Access Compliance Report

Public Rights-of-Way

(Curb Ramps)

Intersection ID: 5009	Main Street: OAK_DR	Cross Street: FOX_POINT_DR	Location: NE
ADA ID: A18D77AA9EA6	Ramp Type: PerpDiag	Initial Pass/Fail: Fail	Overall Compliance: No
			Severity Score: 33.75

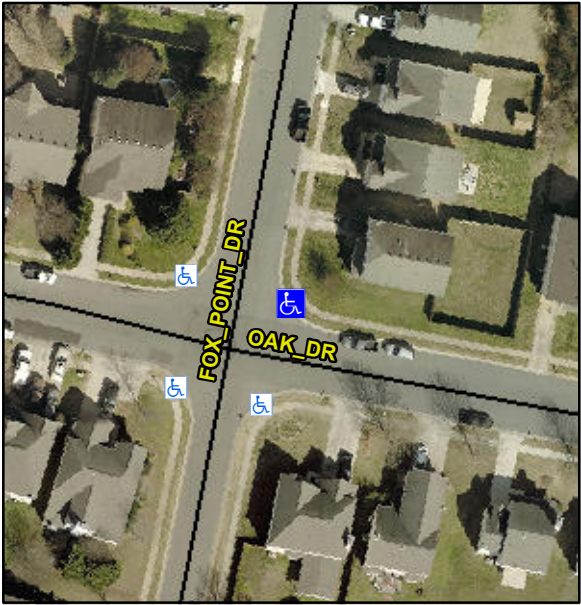
Codes/Mitigation Info/Possible Solution			Field Measurements/Component Compliance		
	Possible Solutions:		Compliance	Description	Data
	Remove & Replace Curb Ramp With Two New Directional Ramps or Equivalent.		No	Ramp Length (in)	48.0
			No	Ramp Width (in)	41.0
			N/A	Flare Type LT	N/A
			N/A	Flare Slope LT (%)	N/A
			N/A	Flare Traversable LT?	N/A
			N/A	Landing Length (in)	N/A
			N/A	Landing Width (in)	N/A
			N/A	Landing Slope (%)	N/A
			N/A	Landing X Slope (%)	N/A
<p>Surveyor Notes:</p> <p>N/A</p>			N/A	Landing Curb? (Y/N)	N/A
			N/A	Shared Landing?	N/A
			N/A	Gutter Ponding?	N/A
			N/A	Gutter Lip Ht (in)	1.0
			N/A	Painted X Walk1?	No
				X Walk 1 Direction	To NW
			N/A	X Walk 1 Width (in)	N/A
				X Walk 1 Slope (%)	2.4
				X Walk 1 X Slope (%)	2.7
			N/A	Ramp inside XWalk1?	N/A
<p>PROW/ADA:</p> <p>Not Found, R304.5.1, R304.2.2</p>			N/A	Road Slope (%)	0.6
				Road X Slope (%)	1.1
			N/A	Any Obstructions?	N/A
